Draft  
Technical Evaluation Report  
for the Proposed Revised  
Reclamation Plan for the Atlas  
Corporation Moab Mill

Source Material License No. SUA 917  
Docket No. 40-3453  
Atlas Corporation

**U.S. Nuclear Regulatory Commission**

January 1996

Figure 5-1: Monitoring Well Locations, Atlas Uranium Mill

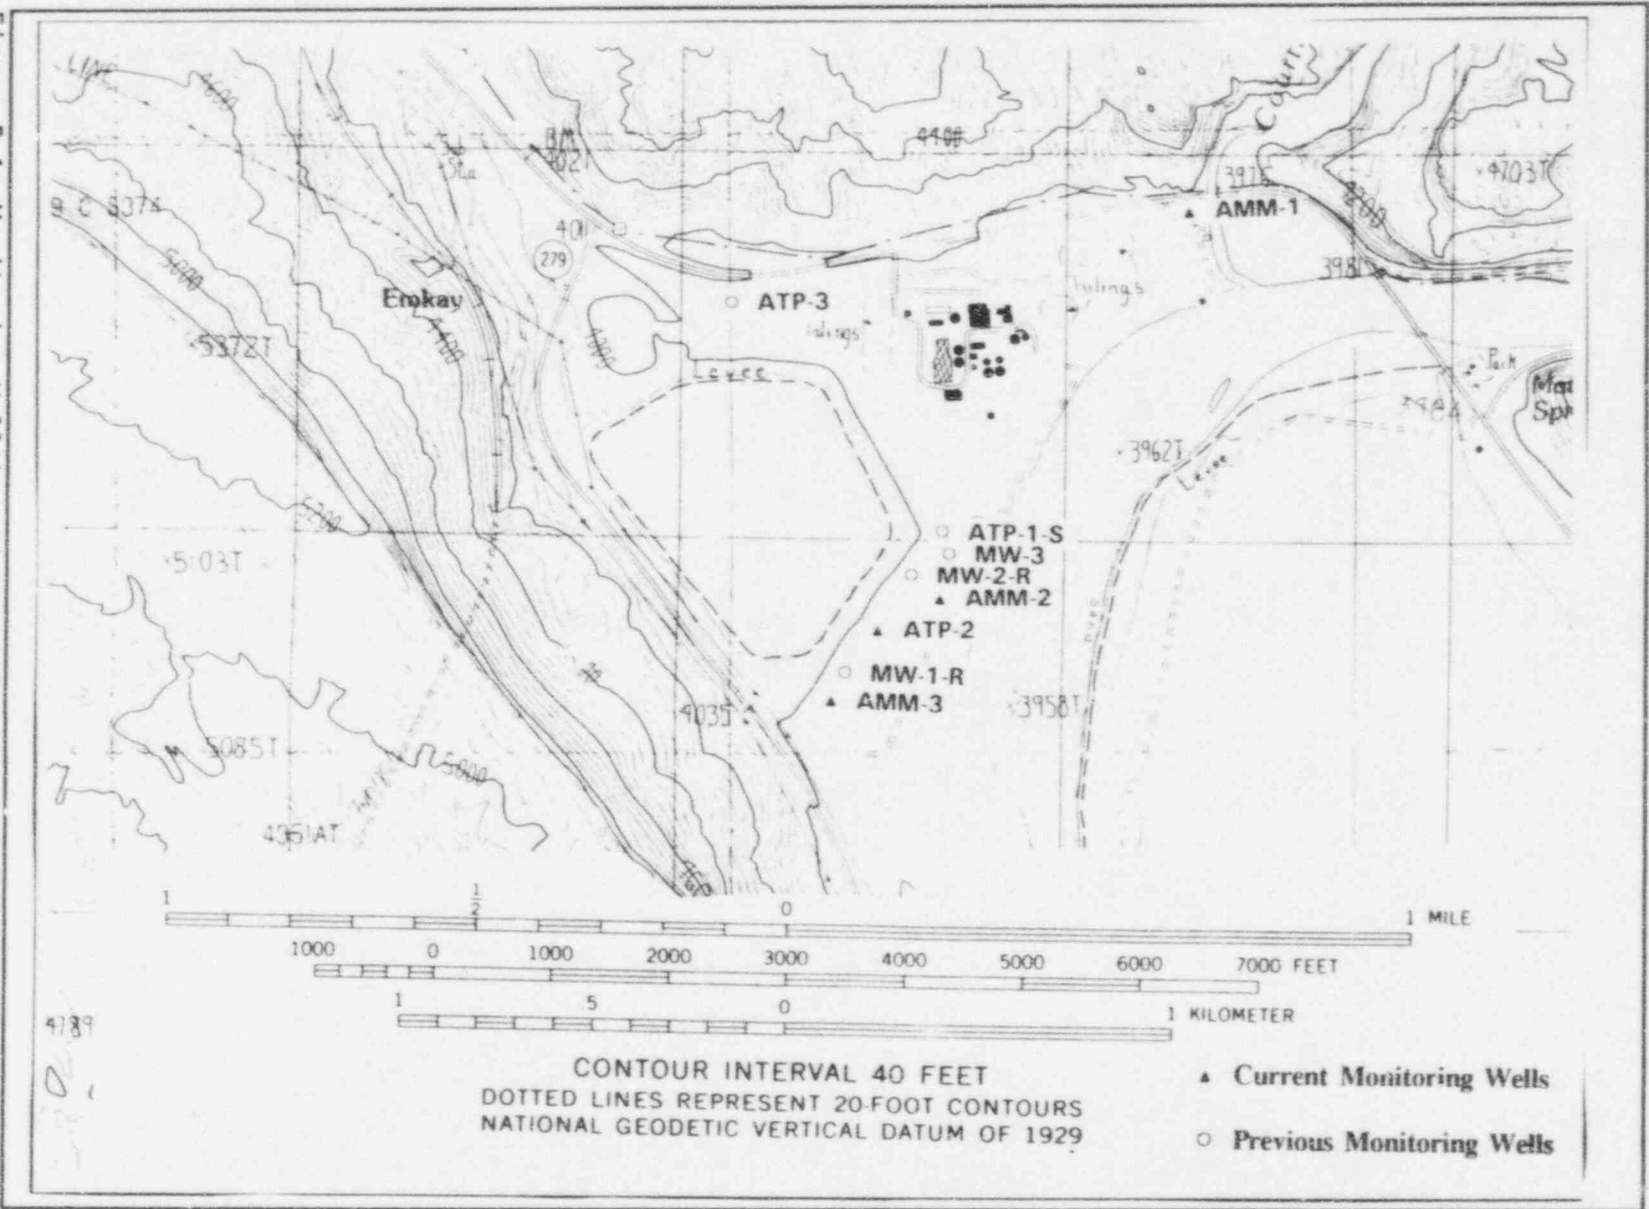
14. Consequences, with respect to erosion protection, of severe landslides have not been adequately addressed.	4.5.1.3.2
15. The licensee must provide additional data to support its interpretation of groundwater flow directions and gradients in the alluvial aquifer near the southern property boundary of the site.	5.2.4

16. The licensee must provide data showing that monitoring well AMM-1 is not influenced by contaminants from the former ore storage pad.	5.2.5
17. The licensee must clarify whether it plans to take engineering credit for any disposal cell component for meeting compliance with the groundwater protection standards for the site. If engineering credit is taken, costs associated with achieving the necessary cover permeability must be incorporated into the reclamation plan.	5.3

Based on the available information, NRC staff concludes that the licensee's interpretation of groundwater flow direction and gradient is reasonable, with the exception of the area associated with the southern extent of the tailings, near the southern property boundary. The licensee interprets that alluvial groundwater flows nearly perpendicular from the upland area southwest of the site, toward the river. Monitoring well and piezometer data in this area are limited to piezometer B-7 in the tailings pile and monitoring wells AMM-3 and MW-1-R situated near the embankment toe.

Figure 6-1: Reclaimed impoundment soil cover profiles, taken from drawing No. 88-067-A112, March 21, 1995 Atlas submittal

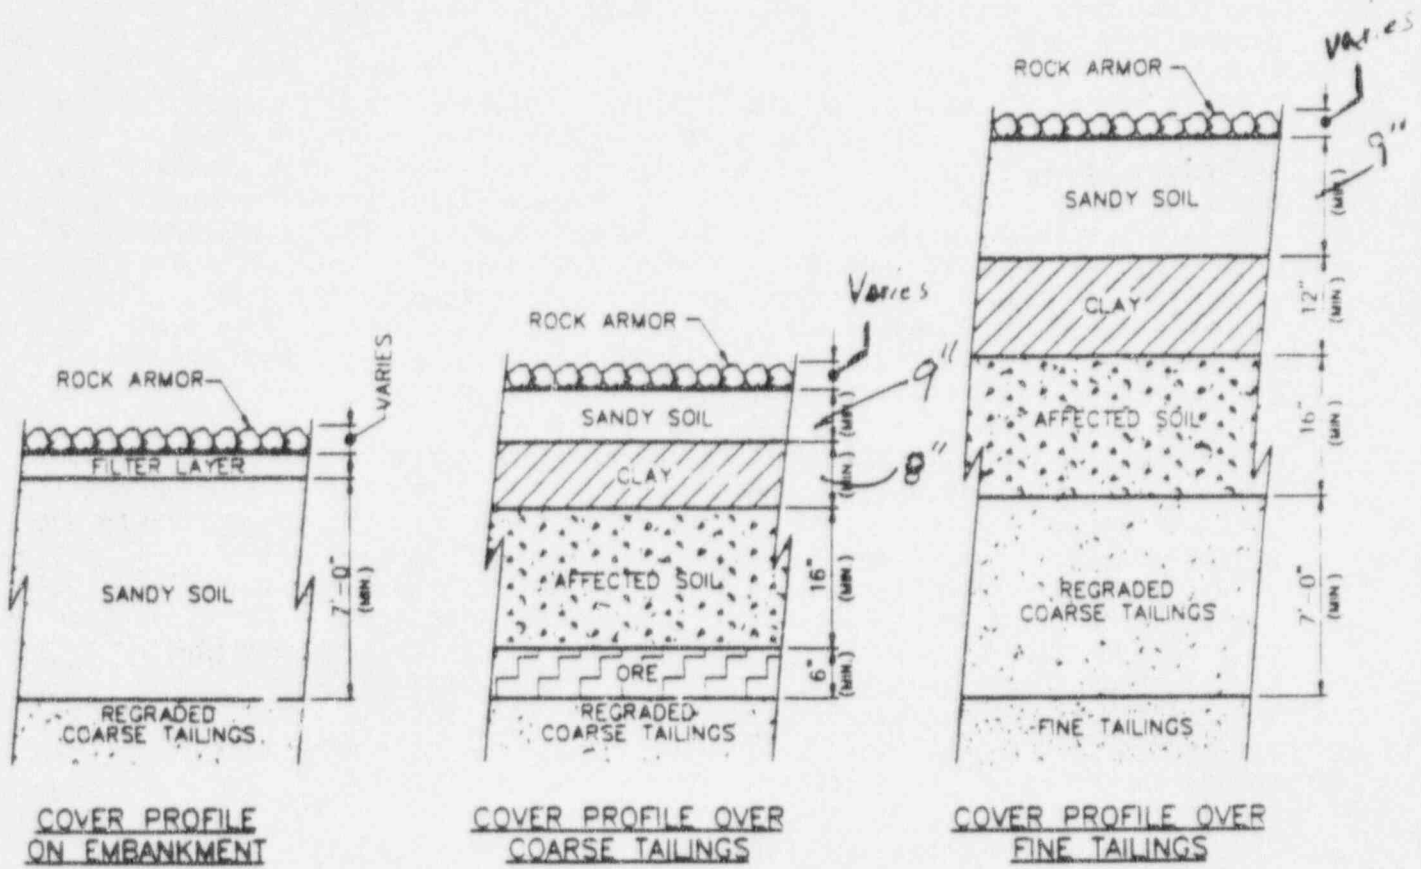
18. The licensee must provide a sampling plan for Ra-226 analysis of the upper 3 to 4 feet of coarse tailings and the technical basis for modeling the coarse tailings on the sideslopes as being homogenous (i.e., a single layer) for Ra-226 concentration.	6.2.2

In response to NRC staff comments, Atlas proposed a revised radon barrier design for the top slope (i.e., Areas 2 and 3) in March 1995 (see Figure 6.1), that was based on a revised radon model that relies on more conservative parameter values. In the revised design, the radon barrier minimum thickness (clay plus sandy layers) has been increased to 17 inches over the coarse tailings area, and to 21 inches over the fine tailings area. The clay layer will be a minimum of 8 inches thick over the coarse tailings area and 12 inches thick over the fine tailings area. The clean soil layer minimum thickness has been increased to 9 inches over the entire top slope. Because the side slopes do not contain fine tailings or the clay layer, Atlas did not change the model for that area.
